Review of the Tunnel Crossing of the New River in Fort Lauderdale, FL

Document no: Technical Memorandum
Version: FINAL Rev 2.1

Client Name: Broward County

Jacobs Project No.: D3864500
June 7, 2024

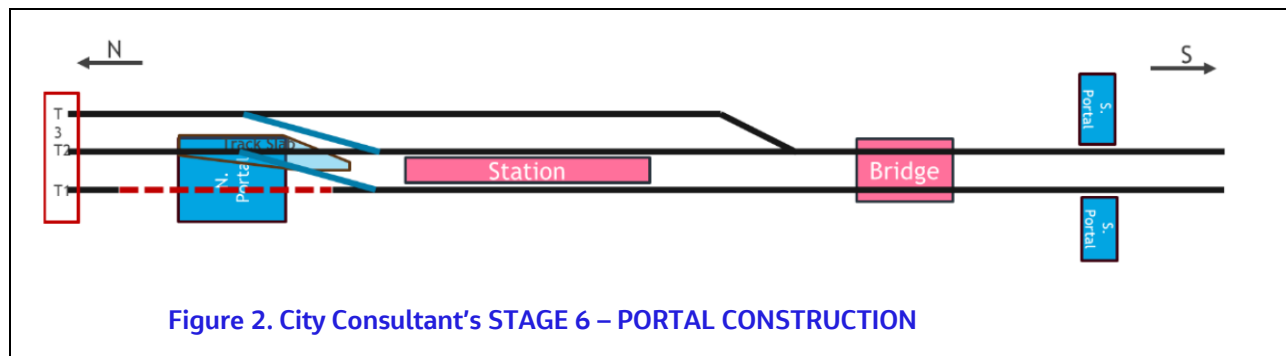
The transition between the cut-and-cover and TBM tunnel sections needs to be clarified. The required bellmouth structure may interfere with the existing railway construction sequence. Refer to [Figure 1](#) for Transition From Tunnel Approach to Cut-and-Cover on North and South Ends.

Figure 4. Port Miami Tunnel (POMT) TBM Break-in Support of Excavation With Secant Pile And Cutter Soil Mixing Wall

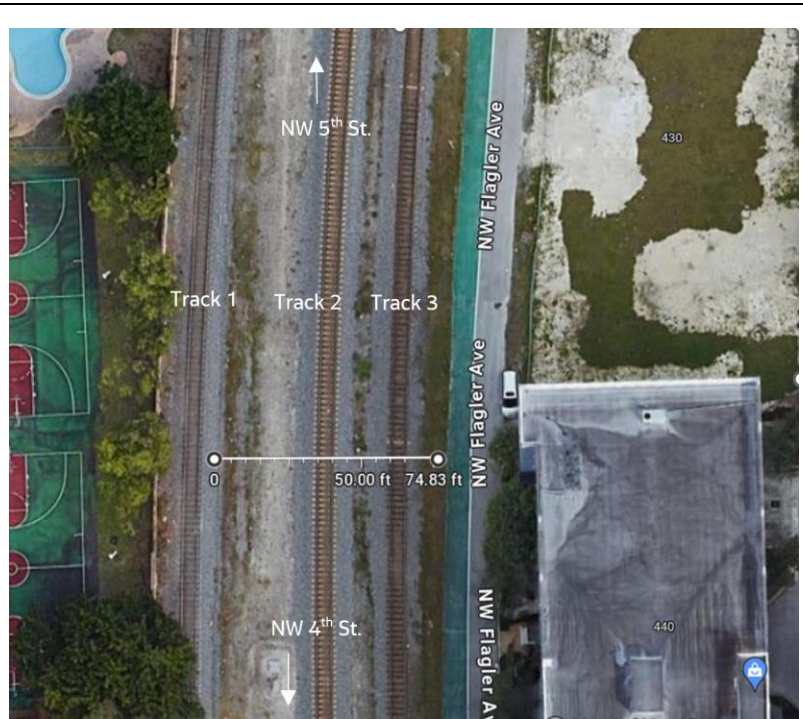
The **Figure 4** below shows a typical TBM Break-in/Break-out SOE scheme utilized for the (POMT). The overall width of this section including the CSM wall is about 110 feet.

Figure 5. Proposed North Portal location between NW 4th and NW 5th Streets

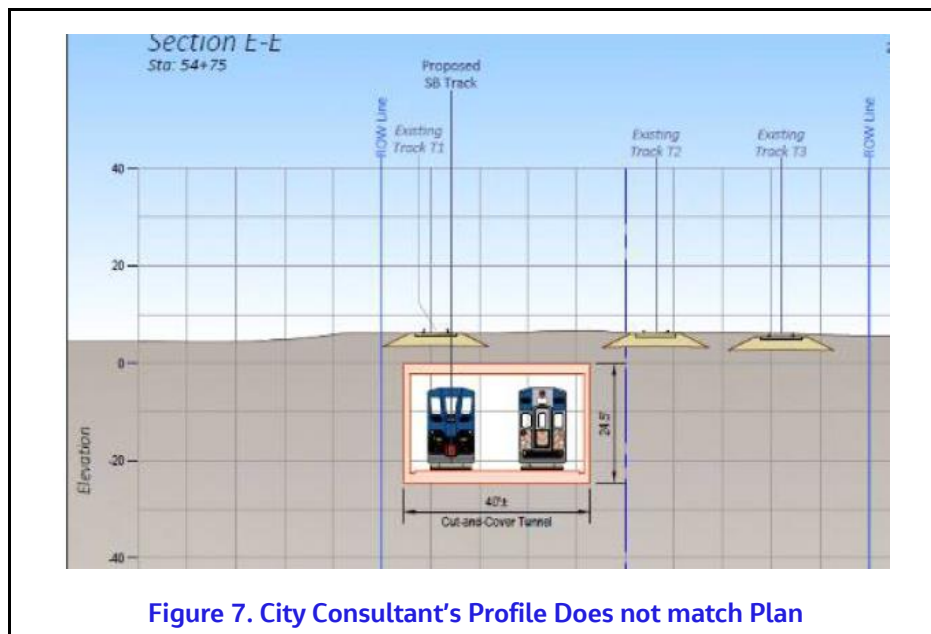
One combined TBM launching and receiving pit was proposed at the North portal, as previously shown on **Figure 2**. The construction of this TBM launching and receiving pit is unfeasible for the following reasons:

- Constructing the receiving pit west of Track 1 will require significant encroachment on adjacent property, since minimum space exists between Track 1 and the ROW.

- Minimum combined TBM launching and receiving pit is about 82 feet, which includes the two TBM outside diameter (28 feet each), pillar between two tunnels (10 feet, which needs extensive ground improvement to keep tunnel stability during construction), 3 feet SOE wall on each side (6 feet total), and 5 feet clearance each side of the SOE.

- The TBM launching and receiving pit will encroach not just Track 2, but also Track 3.

Refer to **Figure 5** for North Portal clearances.

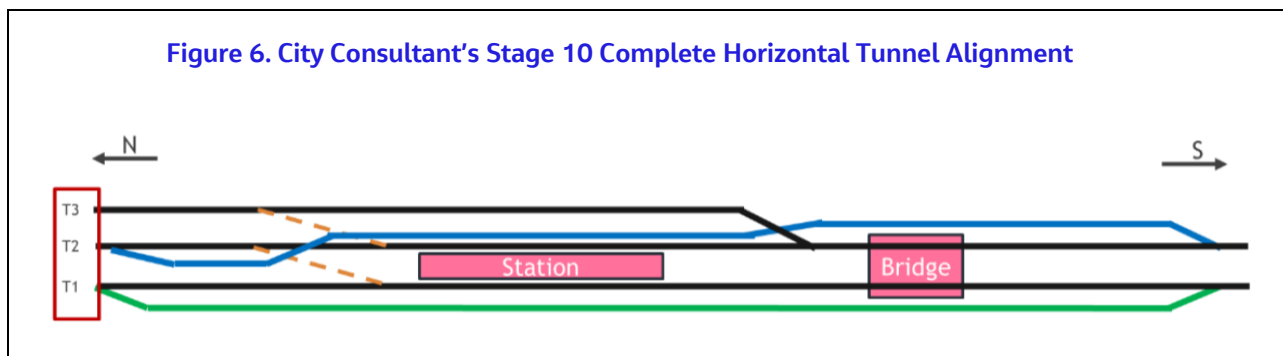
The transition from the underground track to the surface track on the North end of the alignment has some unrealistic horizontal curves. As shown in Figure 6 without a geometric layout, the total tunnel length of the proposed scheme cannot be verified because of the several horizontal and vertical curves. The actual tunnel length could be longer than that proposed in order to accommodate the minimum geometry for the curves. In addition, the two "S" curves shown on the north bound underground track will be difficult for TBM excavation. These "S" curves also need to follow railroad operational and safety requirements.

The plan for the northern segment of the tunnel depicted, shown to be SEM and Cut & Cover, does not match the profile. The plan shows it on the West side of the ROW, yet the Cross Section shows it on the East side of the ROW. Refer to section 3.4.2 for discussion related to railroad vertical and horizontal curves.

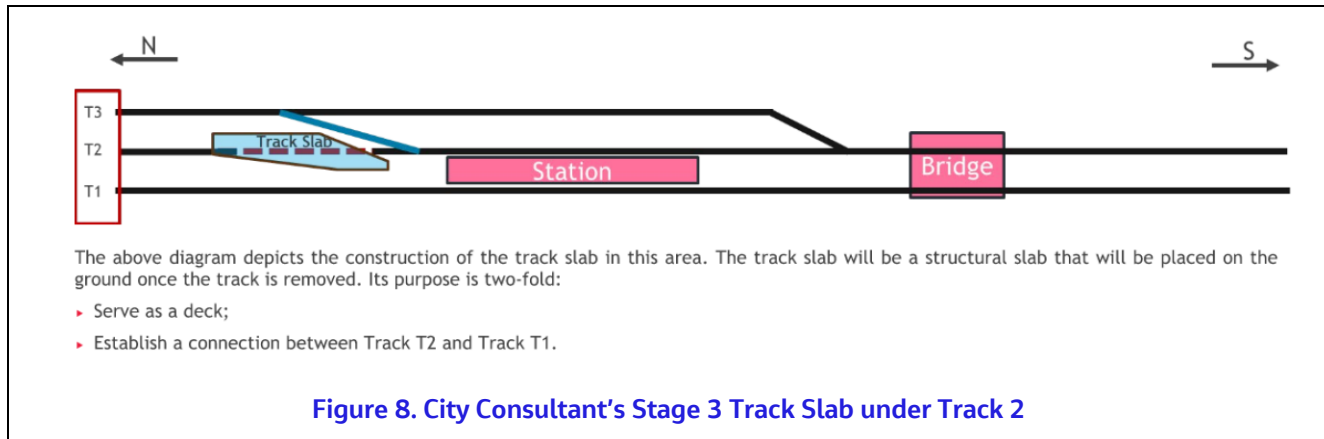
As mentioned earlier, the TBM launching and receiving pit dimension will encroach on Track 2 and Track 3 due to the total dimension and clearance required. The proposed surface track slab as part of the future cut-and-cover tunnel roof structure is not desirable. As shown on Figure 8 below, the proposed Stage 3

from the City Consultant's construction sequencing solution will be difficult to achieve, or unfeasible from structural and waterproofing perspectives. In addition, all the edges of the "slab" are cold joints, where waterproofing detail requires special attention for its long-term performance.

Figure 9. City Consultant's Proposed Underground Access/Exit Shaft at Station Location

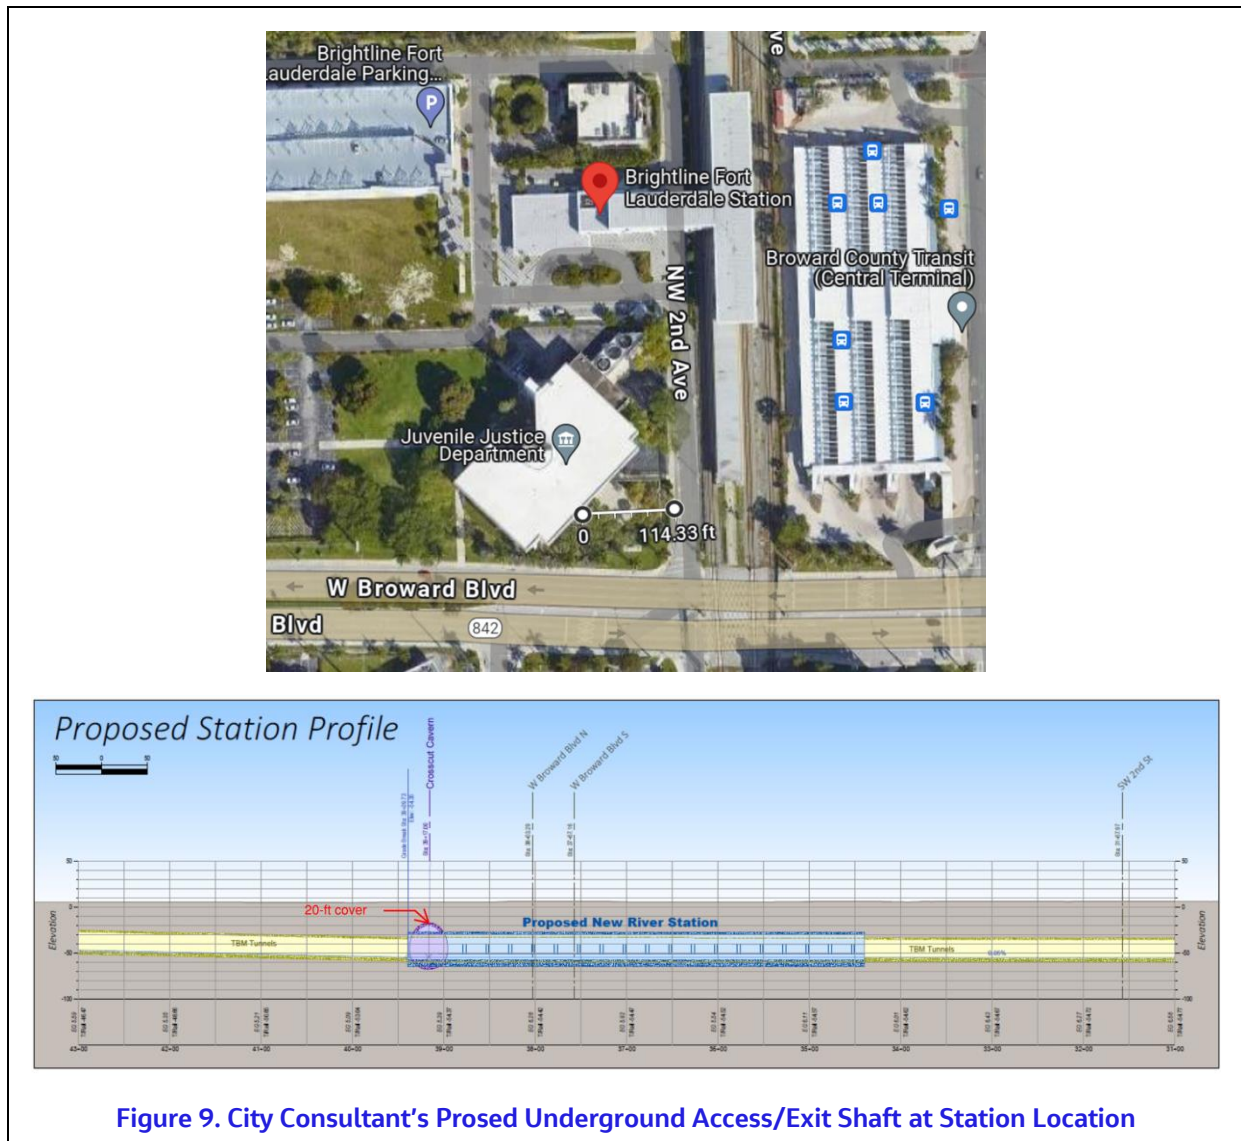
The proposed underground station to serve the commuter rail passengers is located south of the existing Brightline station, underneath Broward Blvd. The proposed station's access shaft will be located from the vacant lot of the existing Juvenile Justice Department's building, as shown in [Figure 9](#).

The size of the lot for an access/exit shaft is small from a construction perspective. The shaft has to house all underground systems operation and ventilation equipment in addition to passenger circulation. In addition, the station requires at least two underground egresses to the surface; only one is provided. An additional means of egress will be required for emergency exit and access purposes.

Figure 10. City Consultant's Proposed Underground Station Plan and Profile

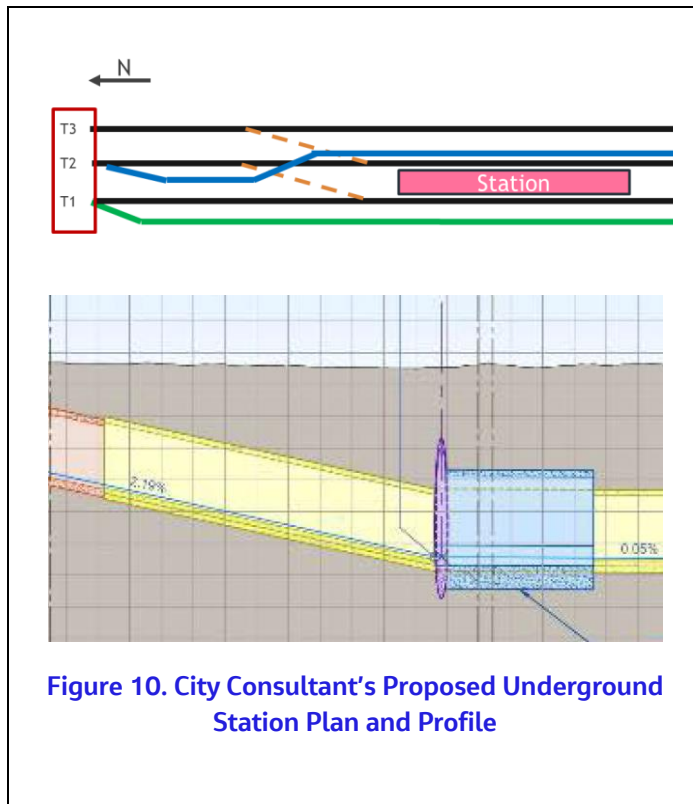
As shown in **Figure 10** the transition to and from north of the station with a vertical slope of 2.19% combined with a horizontal curve is unfeasible, and to accommodate it may require a longer tunnel. Section 3.7.1 of the AREMA Manual provides details related to Compensated Gradients, where a curve on a slope needs to be compensated 0.04% per degree of curve, to account for the added resistance of a train on a curve. Therefore, reducing the slope could be used on a tangent section of track.

Figure 11. Jacobs Verified Tunnel Vertical Slopes

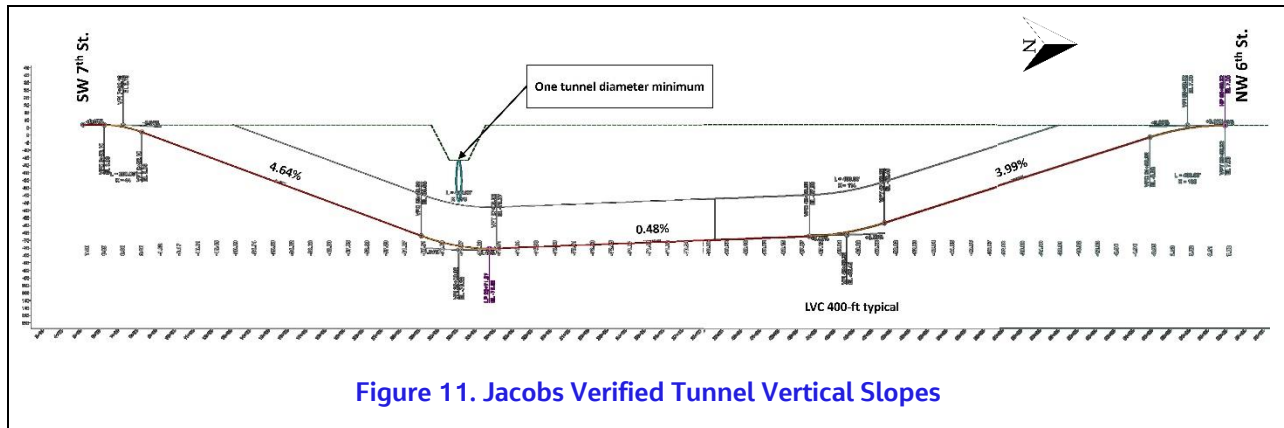
Looking at the overall tunnel profile, the profile does not show vertical curves necessary to join each of the tunnel segments. A review of the proposed design was performed in comparison to what the AREMA Manual of Engineering (2023) Commuter and Intercity Rail Systems applicable sections recommend. A summary of the findings related to the Vertical and Horizontal are as follows:

- Section 3.5.8.1 Vertical Curves has a formula to calculate the minimum curve length. The impact of this is either holding the vertical point of intersection (VPI) and increasing the length of the tunnel, or impacting the grade crossings and in the case of the station, shifting the platform location south. Alternatively, hold the end points of the vertical alignment, which is controlled by existing roadway crossings (NW 6th Street on the northern limit and SW

7th Street on the southern limit), thereby increasing the grades beyond allowable. The length of vertical curves (LVC) varies based on assumed design speed, therefore, a LVC (50 mph) is 400 feet.

- Section 3.5.8.2 Grades: notes that 3-4% grade is the upper limit of allowable intercity or commuter rail service for short distances, whereas 2-3% grades are recommended.
- Section 3.5.8.5 Compensated Grades: the recommended practice is to utilize compensated grades where horizontal and vertical curve coexist.
- Grades increase substantially as illustrated below, and they exceed allowable. Refer to **Figure 11** for the verified slopes holding the reports portal location. A longer tunnel is required to reduce the maximum grades to acceptable values

Figure 13. Geological profile under New River (Quest)

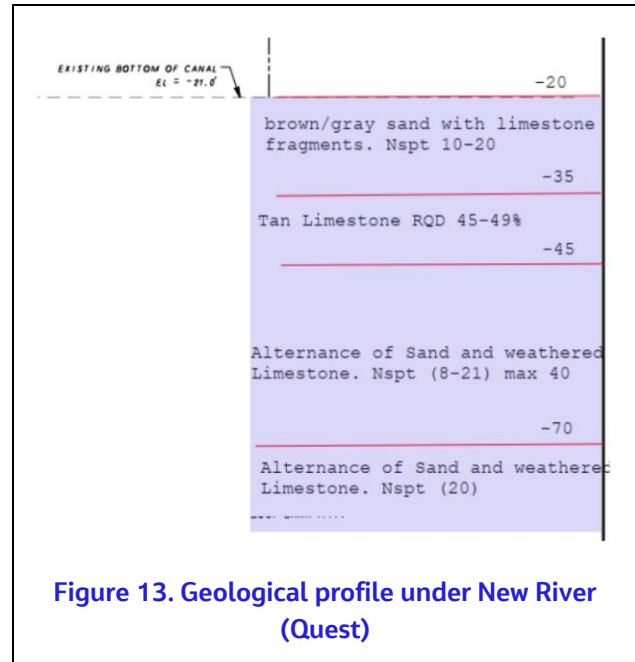
Borehole B6 is the most likely representative of the ground conditions at the New River underpass. The results of the boring indicate that the ground is mostly soil, with a small layer (about 10 feet) of weak limestone rock at the tunnel crown. The limestone rock has an RQD (Rock Quality Designation) of 45-49%, which indicates that it is weak and fractured. The weak rock could potentially influence the tunnel excavation. The geological profile under New River is shown in [Figure 13](#).

It is concluded that the City Consultant’s tunnel option will encounter mix-face tunneling condition (some portions in soft ground and some portions in rock). For example, since the proposed tunnel is very shallow, its crown will be exposed to sandy material.

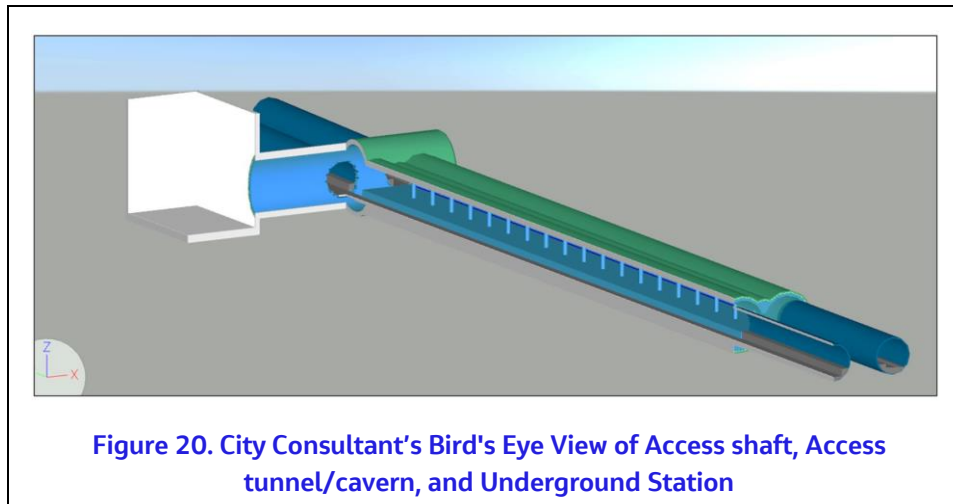
Figure 20 provides a bird's view of the underground station. Construction of the underground station and its access tunnel (leading to the shaft) will be in sand with NSPT (Standard Penetration Test blow-count

number) from 0 to 10 (Quest Borehole B7 – sand layer from ground surface to Elevation -60), which indicates very loose to loose and low strength material (note – NSPT number and its relative Density relationship: 0-4, Very Loose; 4-10, Loose; 10-30, Medium; 30-50, Dense; over 50, Very Dense).

Underground construction in this type of very loose to loose ground with high groundwater table has significant risk of losing ground stability during excavation. A significant amount of ground improvement (such as ground freezing) will be required.
